Access Compliance Report

Public Rights-of-Way

(Curb Ramps)

Intersection ID: 54217	Main Street: GOLF_LINKS_DR	Cross Street: MIDWAY_PARK_DR	Location: NW
ADA ID: 9CDAD4021A52	Ramp Type: Perp	Initial Pass/Fail: Fail	Overall Compliance: No
Severity Score: 12.5			
Codes/Mitigation Info/Possible Solution		Field Measurements/Component Compliance

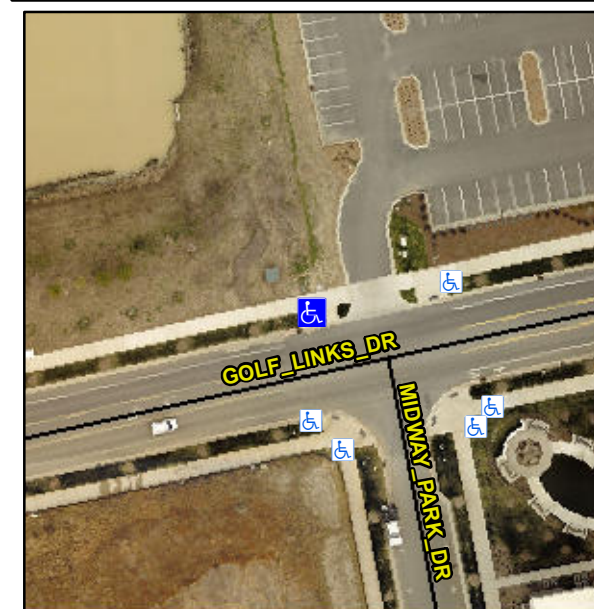
Not Found, R304.2.2

Compliance	Description	Data	Compliance	Description	Data
N/A	Ramp Length (in)	94.0	No	Ramp Slope (%)	9.0
Yes	Ramp Width (in)	60.0	Yes	Ramp XSlope (%)	1.3
N/A	Flare Type LT	N/A	N/A	Flare Type RT	N/A
N/A	Flare Slope LT (%)	N/A	N/A	Flare Slope RT (%)	N/A
N/A	Flare Traversable LT?	N/A	N/A	Flare Traversable RT?	N/A
N/A	Landing Length (in)	N/A	N/A	DWS Provided?	N/A
N/A	Landing Width (in)	N/A	N/A	DWS Contrast?	N/A
N/A	Landing Slope (%)	N/A	N/A	DWS Length (in)	N/A
N/A	Landing X Slope (%)	N/A	N/A	DWS Full Width?	N/A
N/A	Landing Curb? (Y/N)	N/A	N/A	DWS Offset (in)	N/A
N/A	Shared Landing?	N/A			
N/A	Gutter Ponding?	N/A	N/A	Gutter Slope (%)	N/A
N/A	Gutter Lip Ht (in)	N/A	N/A	Gutter X Slope (%)	N/A
N/A	Painted X Walk1?	No	N/A	Painted X Walk2?	N/A
	X Walk 1 Direction	To S		X Walk 2 Direction	N/A
N/A	X Walk 1 Width (in)	N/A	N/A	X Walk 2 Width (in)	N/A
	X Walk 1 Slope (%)	5.0		X Walk 2 Slope (%)	N/A
	X Walk 1 X Slope (%)	0.9		X Walk 2 X Slope (%)	N/A

Remove & Replace Entire Ramp.
